CITY OF ALBUQUERQUE

Re: Christmans Apartments
2040 Willis Pl., SW
Traffic Circulation Layout
Engineer's/Architect's Stamp dated 4-14-16 (J13-D202)

The TCL submittal received 4-14-16 is approved for Building Permit. A copy of the stamped and signed plan will be needed for each of the building permit plans. Please keep the original to be used for certification of the site for final C.O. for Transportation.

SHEET NUMBER
C-1.0

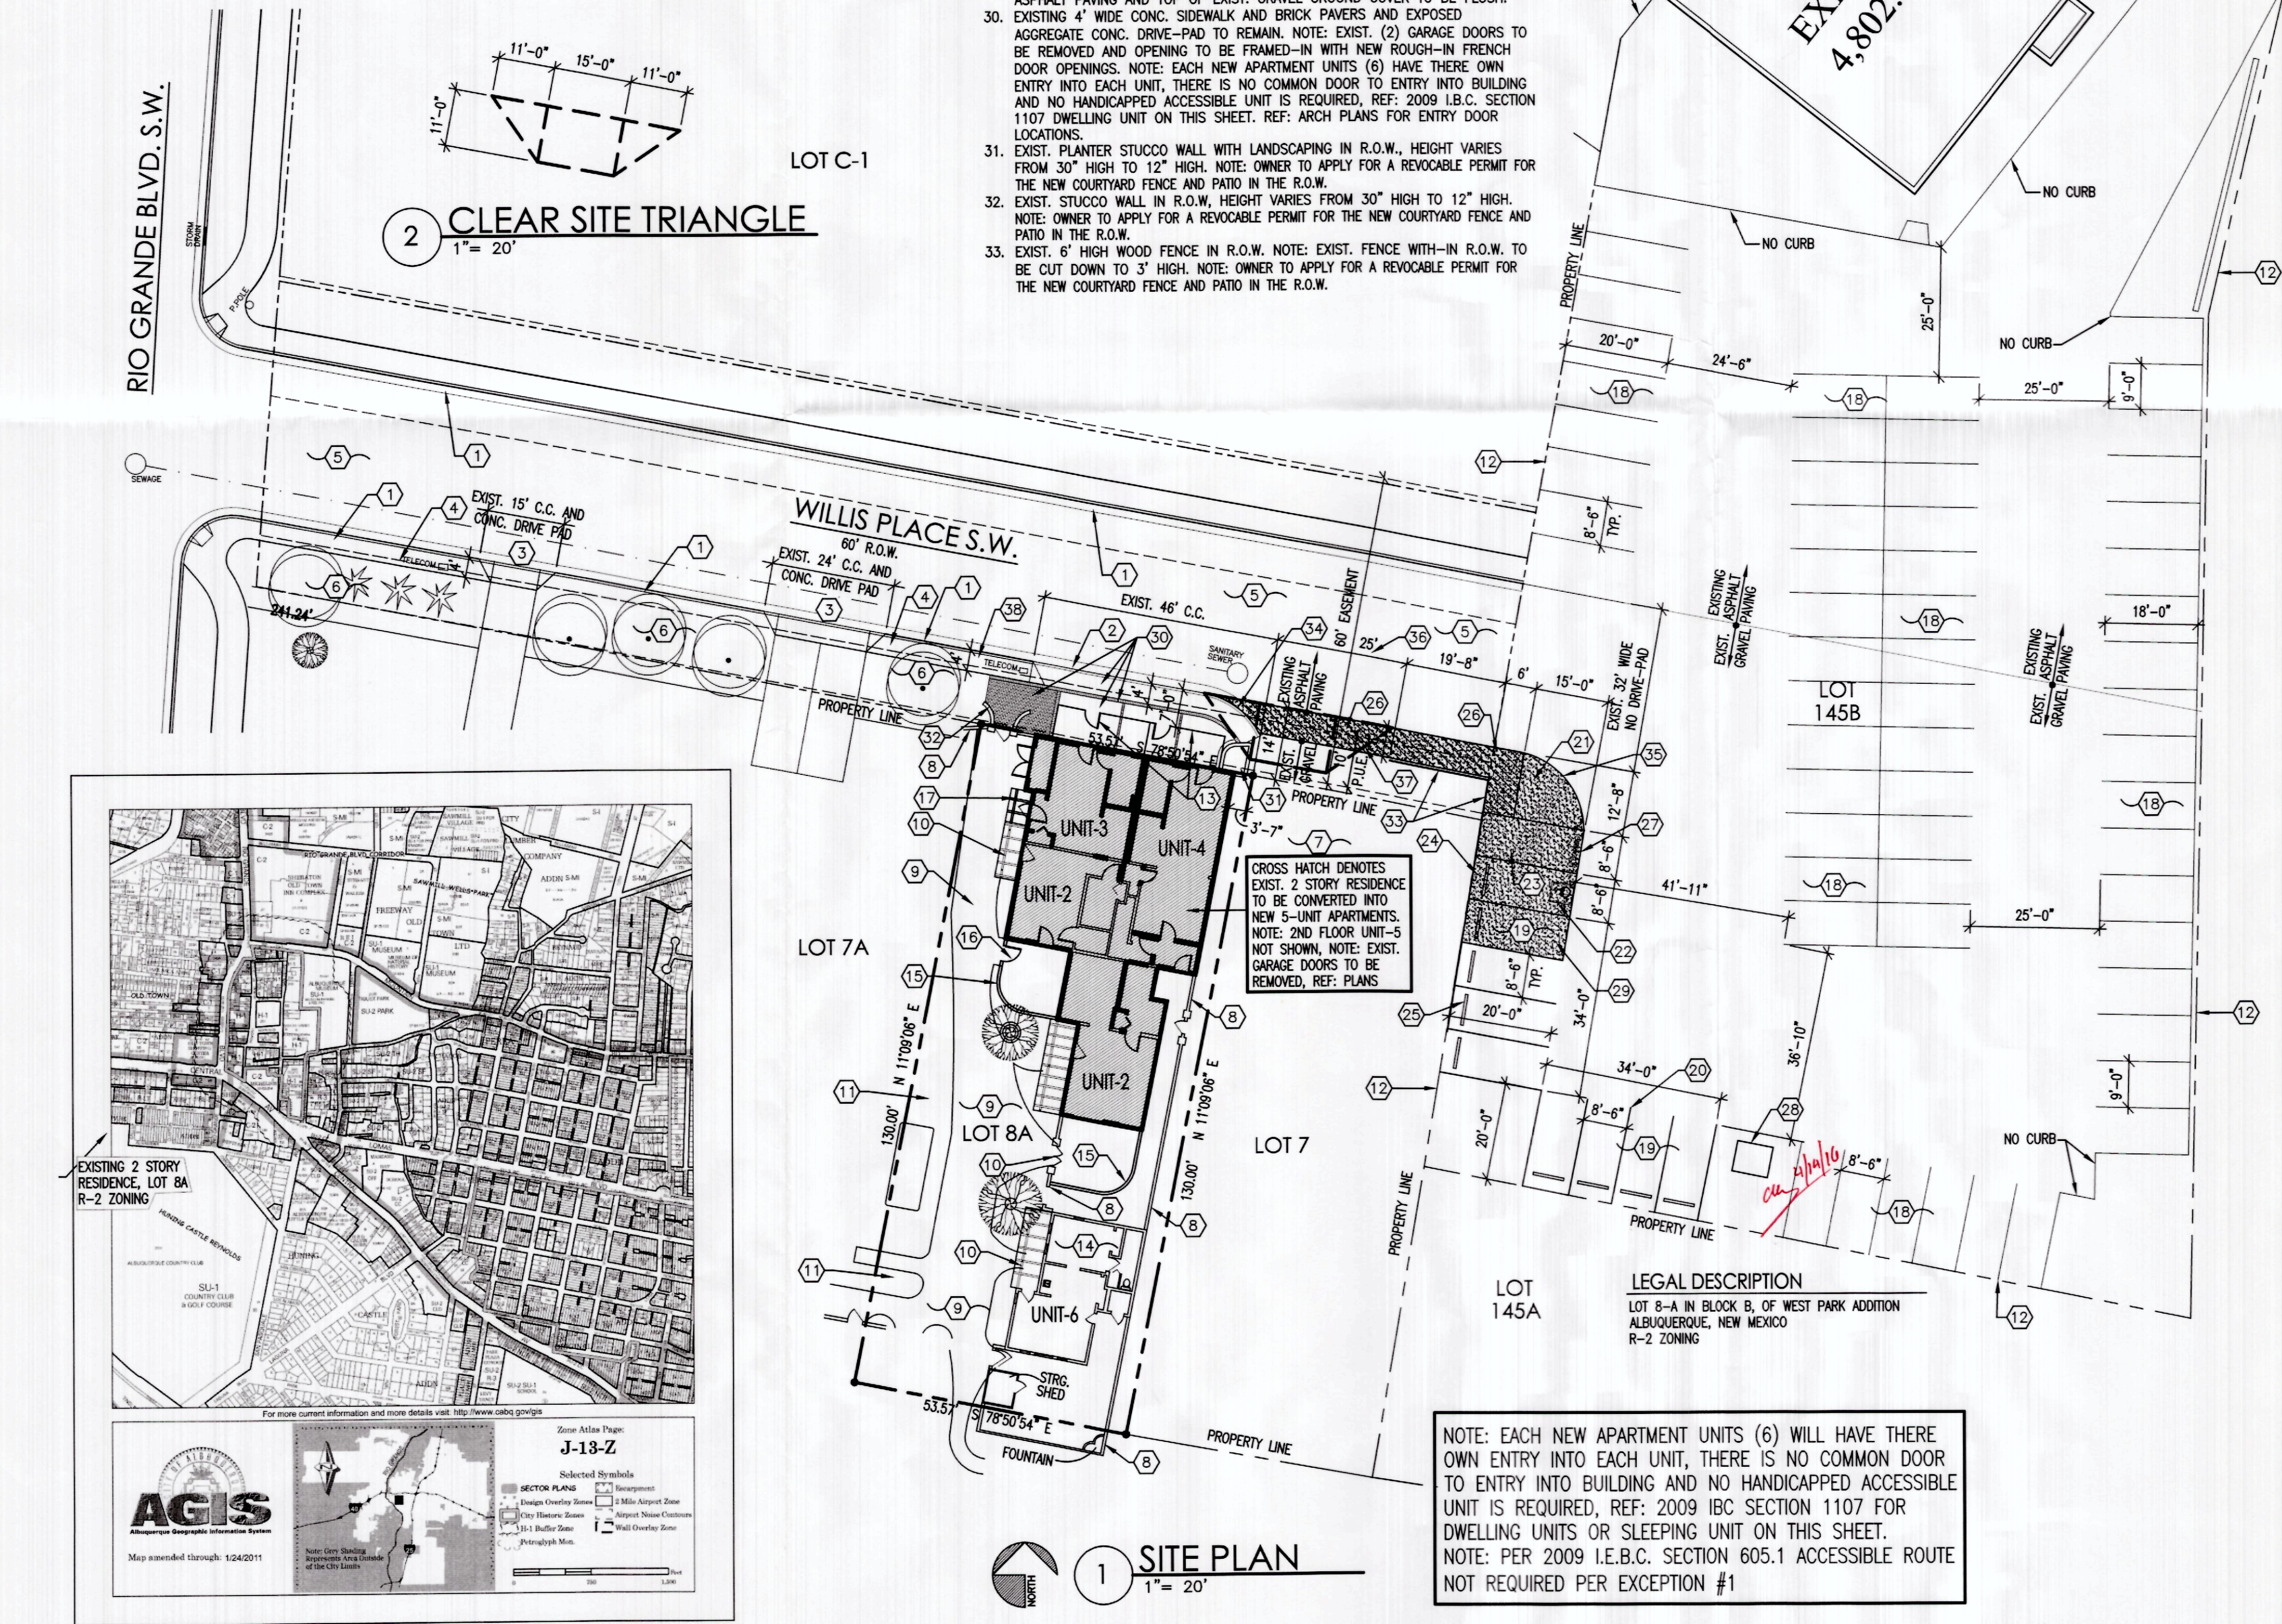
Final C.O. will not be issued until Revocable Permit is acquired.
